DESCRIPTIVE REPORT

Registry No. H-11240

General Locality Kasaan Bay

Sublocality Polk Inlet

Chart 17426 and new docks

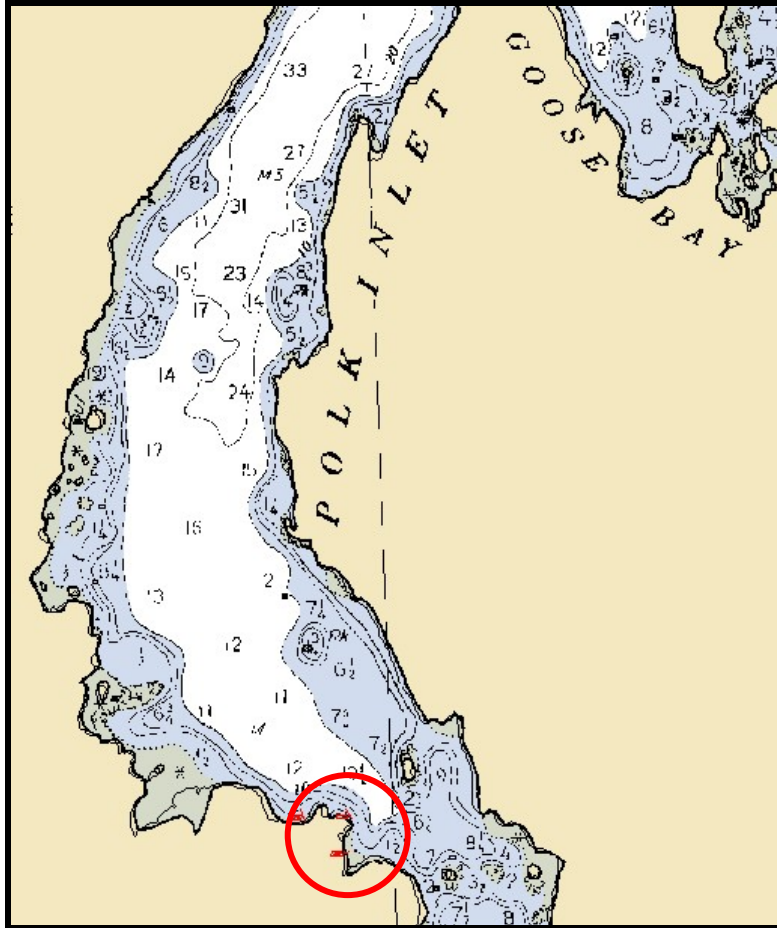
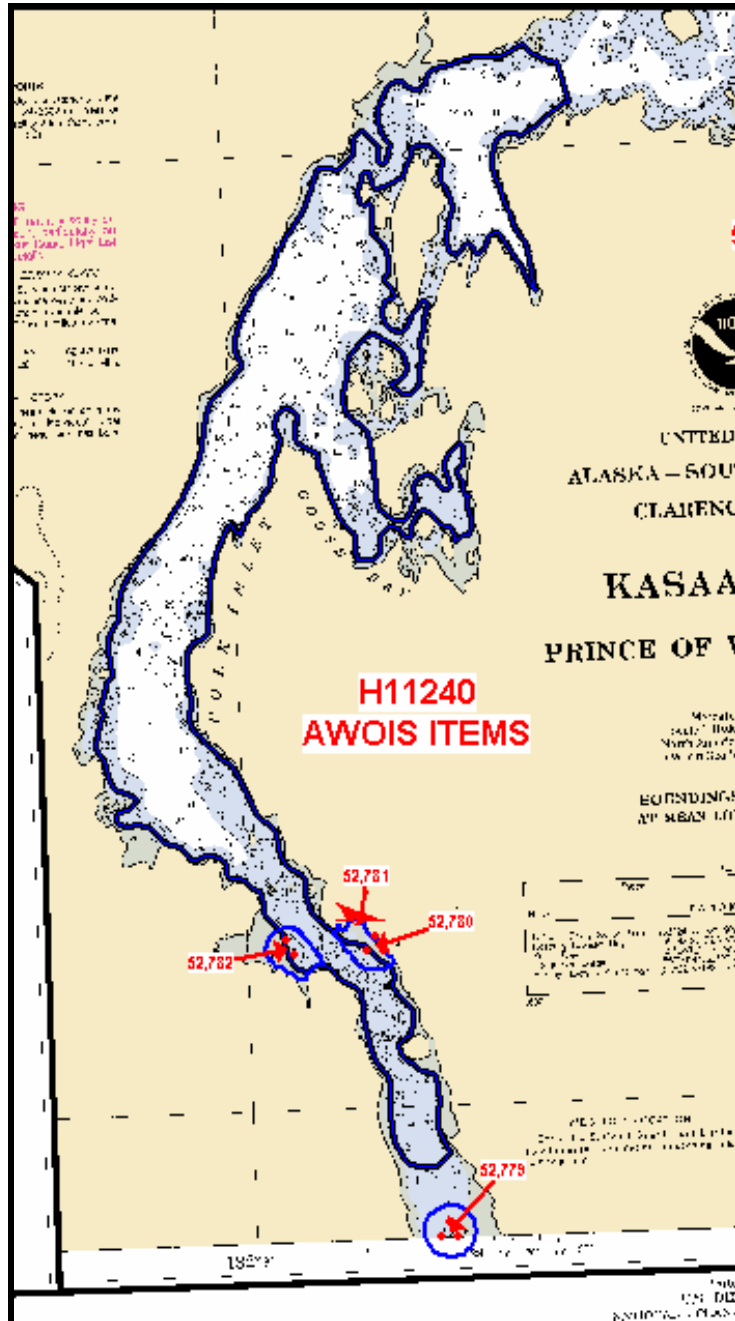
This survey identified three docks not represented in the RSD. They were positioned and included in the detached position log. They are also shown on the smooth sheet.⁷⁴

⁷⁴ Concur with clarification. The docks are charted on 17426, 14th Edition, continuous maintenance raster. Retain as charted the two docks at the following approximate positions:

✚ Lat 55/21/20.6N and Lon 132/30/23.4W

✚ Lat 55/21/14.6N and Lon 132/30/7.9W

Chart dock at approximate position Lat 55/21/20.1N and Lon 132/20/11.3W using smooth sheet position.

AWOIS item 52779, radius, Chart 17426

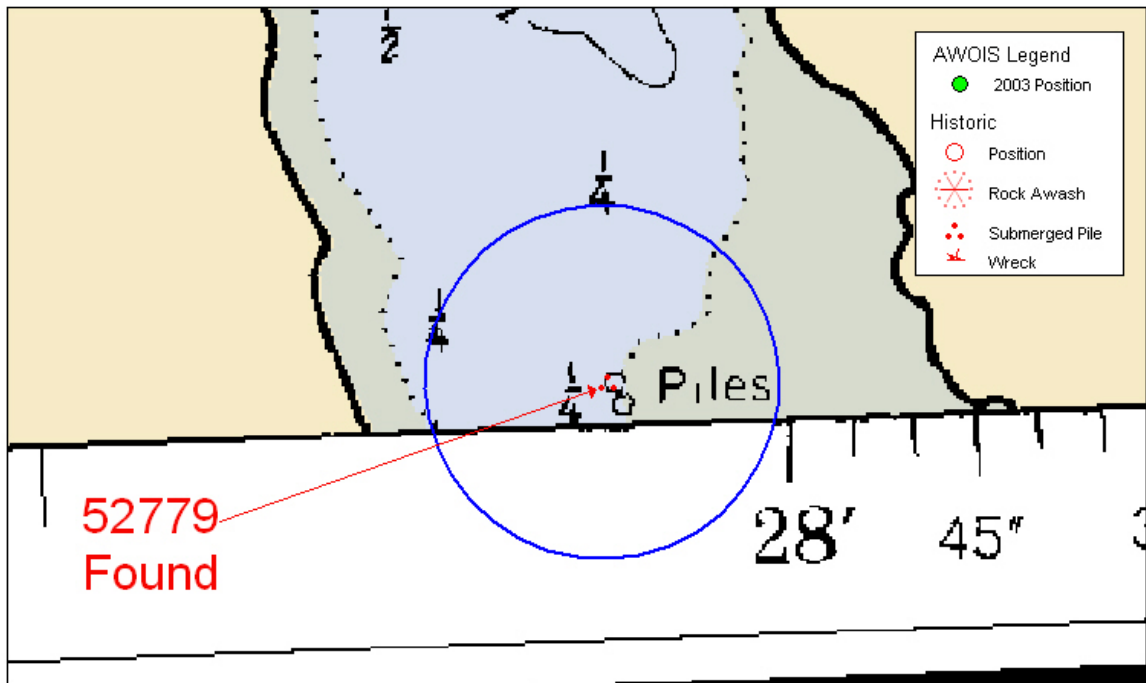
Date(s)/Day Number(s): 08/02/2003 / DN214
Survey Vessel Name: Ducer
Position Numbers/Time: 1,767/18:11:44
Investigation Method: Shoreline Verification
Surveyed Position (NAD83): Search position: Lat 55°19'34.27"N Long 132°28'19.47"W
Position Determined By: Differential GPS
Investigation Summary: The charted position of this item fell outside the limits of hydrography. The AWOIS radius was fully investigated by a combination of 200% SWMB coverage and visual shoreline investigation. Three pilings were located on a shoal 1500 meters⁷⁵ to the south.⁷⁶

Based on the results of survey H-11240, the hydrographer recommends the piles symbol be retained as charted and left in the database.⁷⁷

⁷⁵ The shoreline verification log estimated the search vessel's position as 550 meters from the piles, not 1500 meters. Retain piles at charted position.

⁷⁶ Concur with clarification. This item is outside the survey limits and does not appear on the smooth sheet. See AWOIS report 52779, attached to this report.

⁷⁷ Concur with clarification. See AWOIS report 52779, attached to this report.

AWOIS item 52780, radius, 2003 bathymetry, Chart 17426

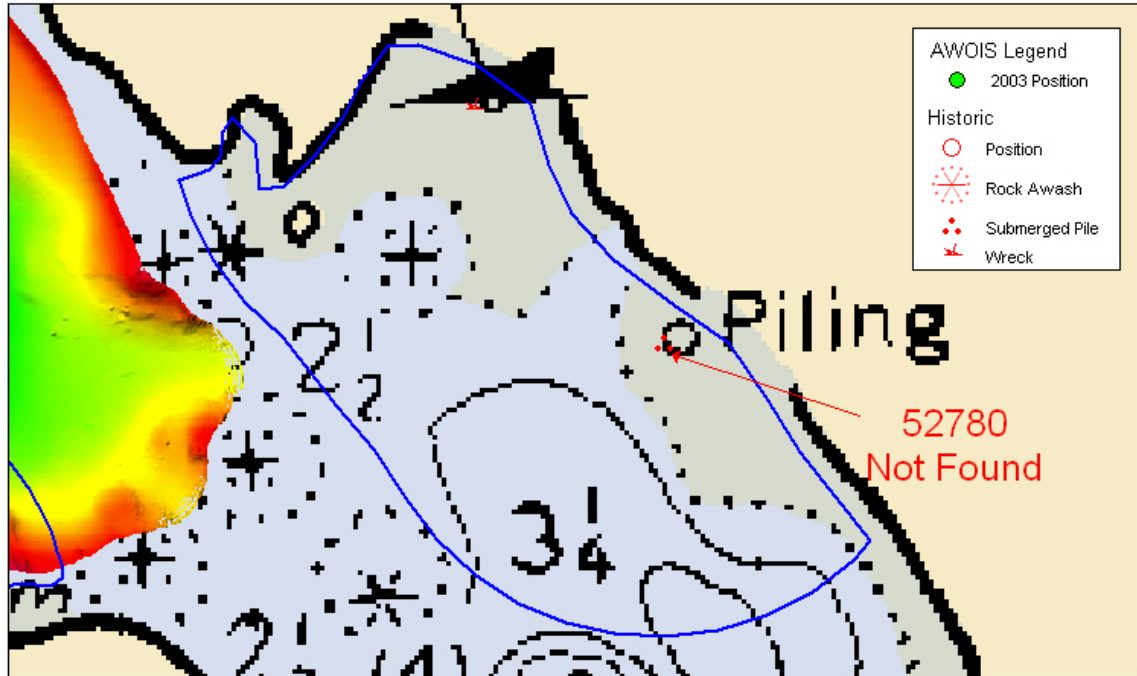
Date(s)/Day Number(s): 08/02/2003 / DN 214
Survey Vessel Name: Ducer
Position Numbers/Time: 1766/17:54:21
Investigation Method: Shoreline Verification and 200%SWMB⁷⁸
Surveyed Position (NAD83): Search Position Lat 55°20'46.21N Lat 132°28'47.68"W
Position Determined By: Differential GPS
Investigation Summary: The charted position of this item fell outside the limits of hydrography. The AWOIS radius was fully investigated by a combination of 200% SWMB coverage⁷⁹ and visual shoreline investigation. A review of the digital terrain model detected no topographic relief.

Based on the results of survey H-11240, the hydrographer recommends the piling symbol be removed from the chart and database.⁸⁰

⁷⁸ Do not concur. The search radius as depicted in the graphic lies beyond the limits of multibeam coverage.

⁷⁹ Do not concur. The search radius as depicted in the graphic lies beyond the limits of multibeam coverage.

⁸⁰ Concur with clarification. See AWOIS form 52780, attached to this report.

AWOIS item 52781, radius, 2003 bathymetry, Chart 17426

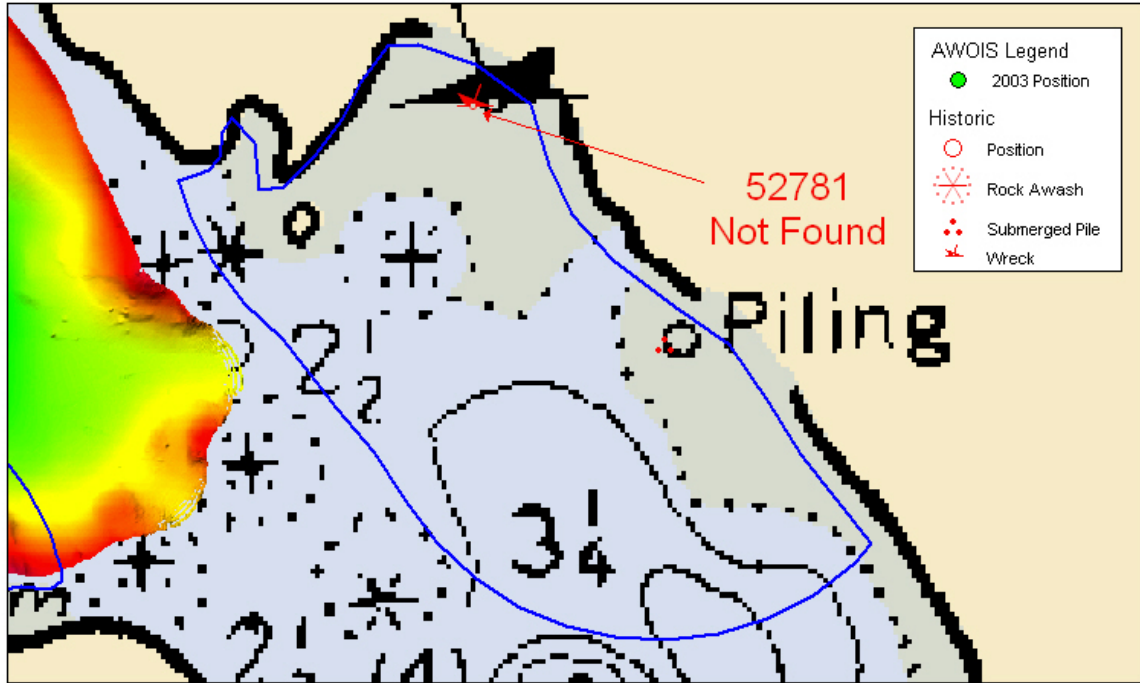
Date(s)/Day Number(s): 08/02/2003 / DN 214
Survey Vessel Name: Ducer
Position Numbers/Time: 1766/17:54:21
Investigation Method: Shallow Water Multi-beam Sonar⁸¹/Shoreline Verification
Surveyed Position (NAD83): Search Position Lat 55°20'46.21N Long 132°28'47.68"W
Position Determined By: Differential GPS
Investigation Summary: The charted position of this item fell outside the limits of hydrography. The AWOIS radius was fully investigated by a combination of 200% SWMB coverage⁸² and visual shoreline investigation. A review of the digital terrain model detected no topographic relief.

Based on the results of survey H-11240, the hydrographer recommends that the wreck symbol be removed from the chart and database.⁸³

⁸¹ Do not concur. The search radius as depicted in the graphic lies beyond the limits of multibeam coverage.

⁸² Do not concur. The search radius as depicted in the graphic lies beyond the limits of multibeam coverage.

⁸³ Concur. See AWOIS report 52781, attached to this report.

AWOIS item 52782, radius, 2003 bathymetry, Chart 17426

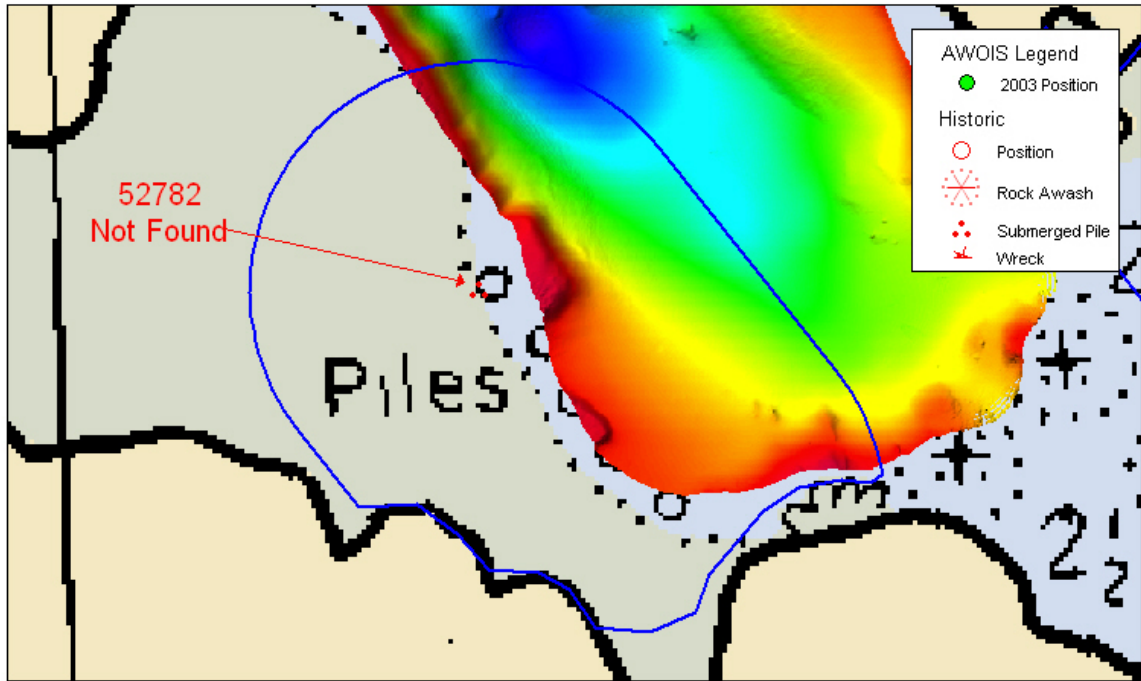
Date(s)/Day Number(s): 08/02/2003 / DN214
Survey Vessel Name: Ducer
Position Numbers/Time: 1762/17:16:50
Investigation Method: Shoreline Verification
Surveyed Position (NAD83): Search Position Lat 55°20' 48.71"N, Long 32°29' 27.21"W
Position Determined By: Differential GPS
Investigation Summary: The charted position of this item fell outside the limits of hydrography. The AWOIS radius was fully investigated by a combination of 200% SWMB coverage and visual shoreline investigation. A review of the digital terrain model detected no topographic relief.

Based on the results of survey H-11240, the hydrographer recommends the piles symbol be removed from the chart and database.⁸⁴

Evaluator comment: Concur with clarification. Remove pile symbol and notation from affected charts.

⁸⁴ Concur with clarification. See AWOIS report 52782, attached to this report.
